Subject: Byron Station Units 1 and 2
Braidwood Station Units 1 and 2
FSAR Revisions
NRC Docket Nos. 50-454, 50-455,
50-456 and 50-457

This is to provide advance copies of answers to questions from the NRC staff regarding the Byron/Braidwood FSAR.

Attachment A to this letter contains responses to questions from the Radiological Assessment Branch transmitted in reference (a). Some voluntary changes to various sections of the FSAR and answers provided previously are also included.

FIGURE E.19-1

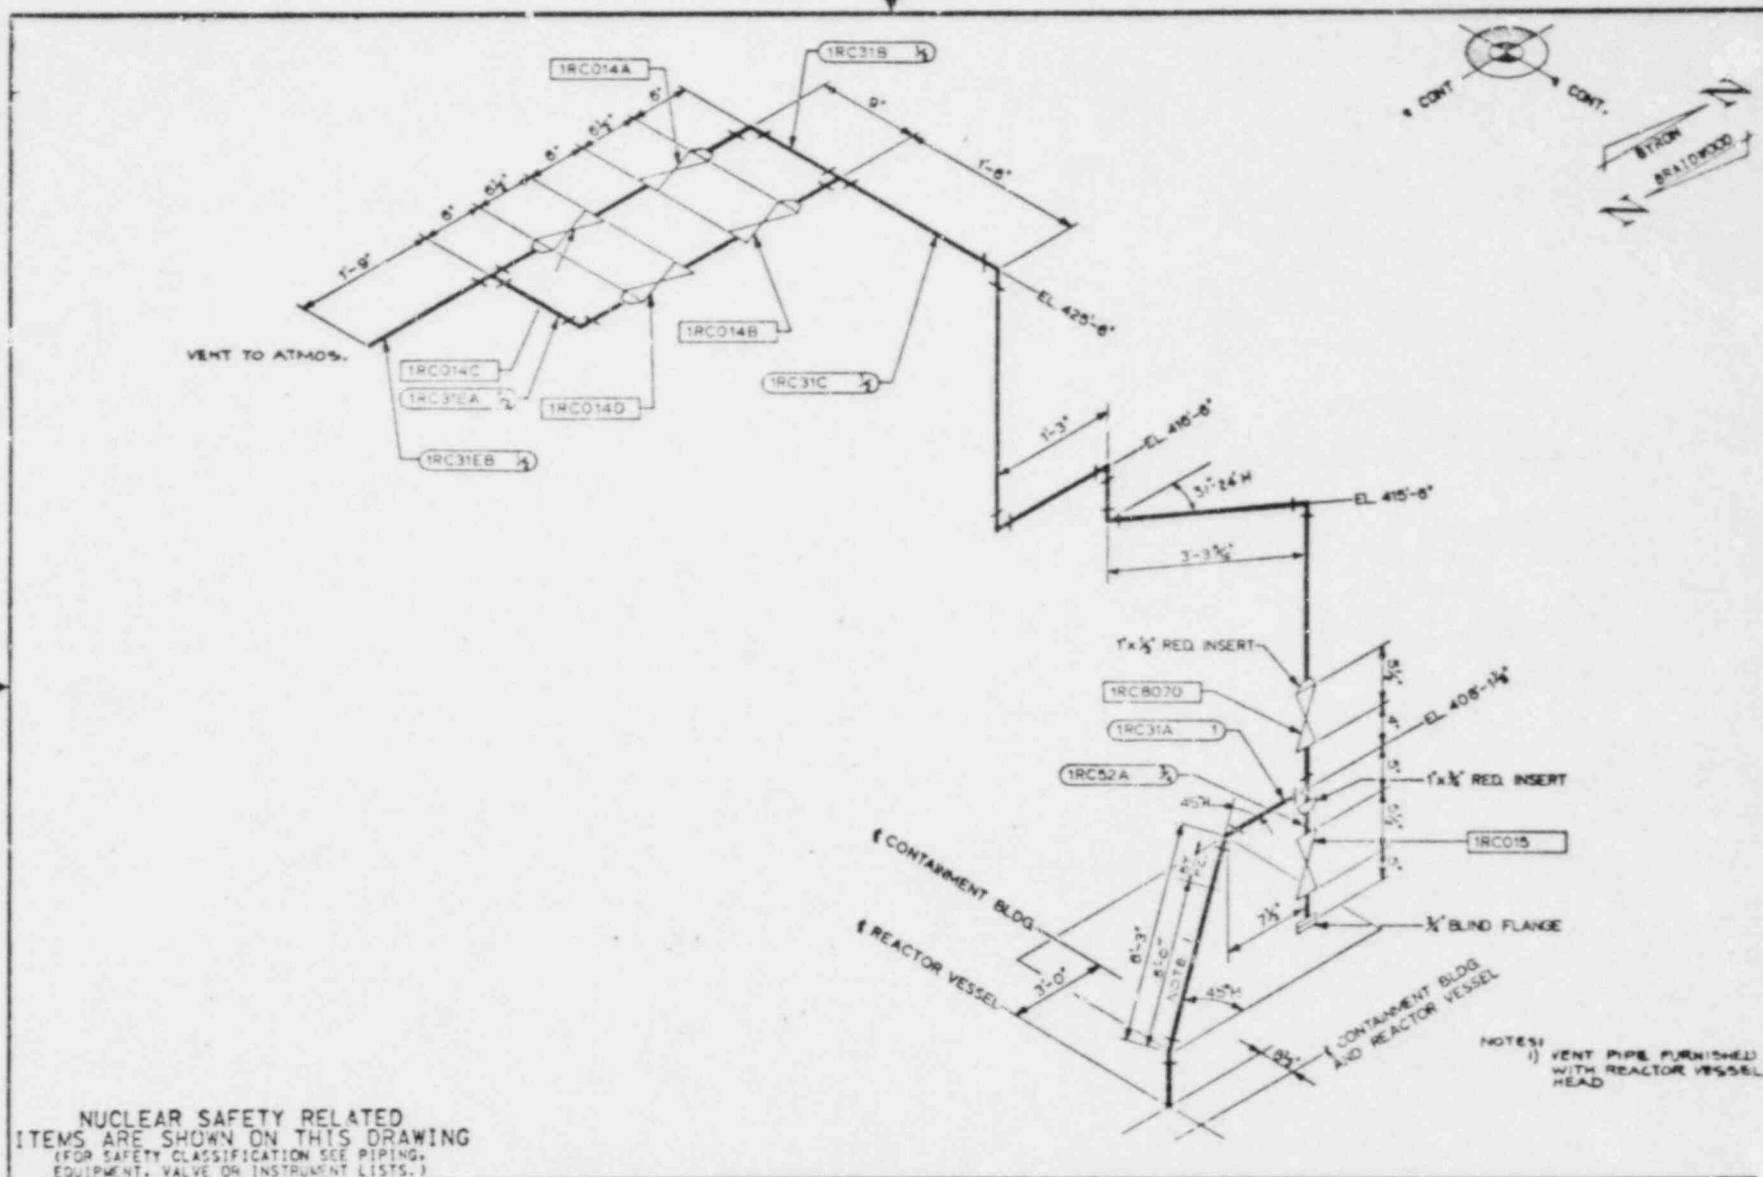
The RCSV line was designed and installed as ASME Section III, Class 1 piping to applicable codes. Final positioning of the discharge of the RCSV minimizes possible impingement on equipment or obstructions. (See Figure E.19-1, RCSV ISOMETRIC DRAWING.)
